our reference: 22000129-R-02
your reference:

14 June 2022

Review of Surface and Ground Water Quality: Windsor Bridge

Figure 16: Plot of Iron concentrations at the north bank locations, post construction.

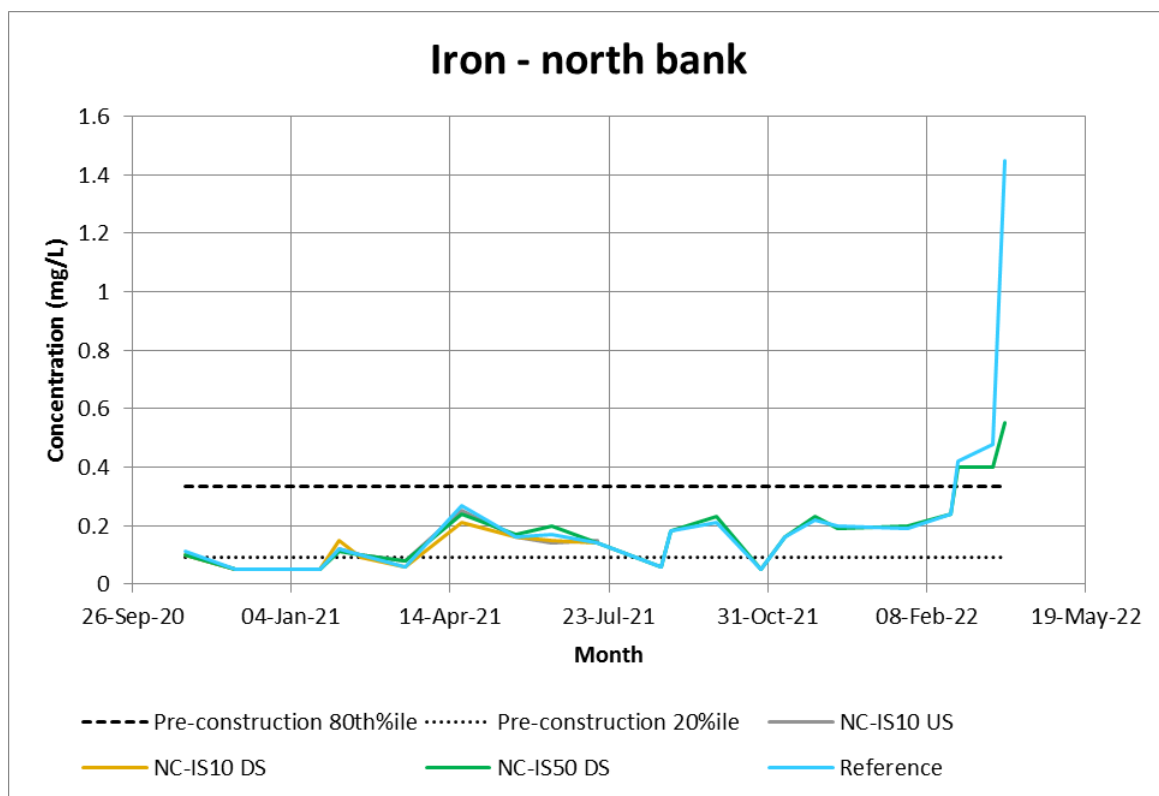
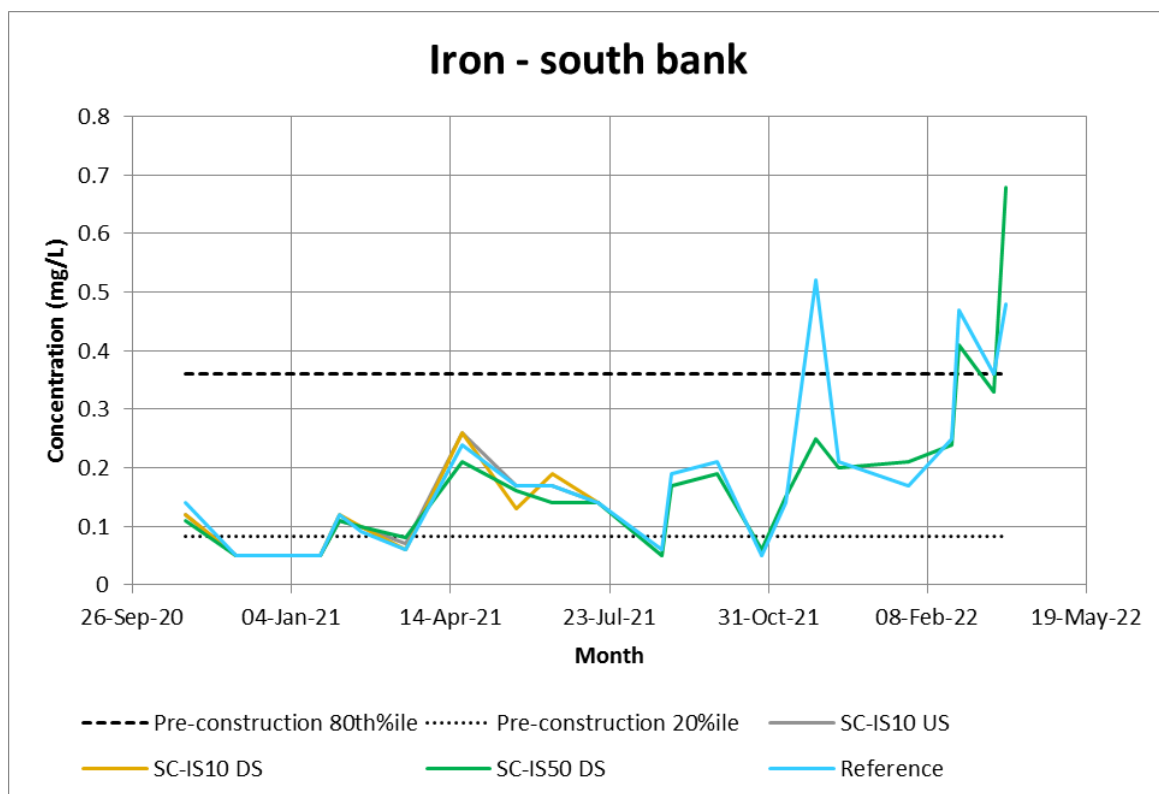
Similar to the observed aluminium concentrations, iron levels were below the ANZECC trigger value of 0.3mg/L and then spiked towards the end of the

monitoring period. Prior to this time there were no increases above the SSTV. The final observed iron concentration for the south bank exceeded the value recorded at the reference site and at the upstream wet weather monitoring site (SC-CS2). As the monitoring occurred after a major flood event (590mm recorded in March 2022) it is difficult to conclude that the increase is based solely as a result of the project when flood water would likely still be contaminated from runoff from an extended catchment well upstream of the project site.
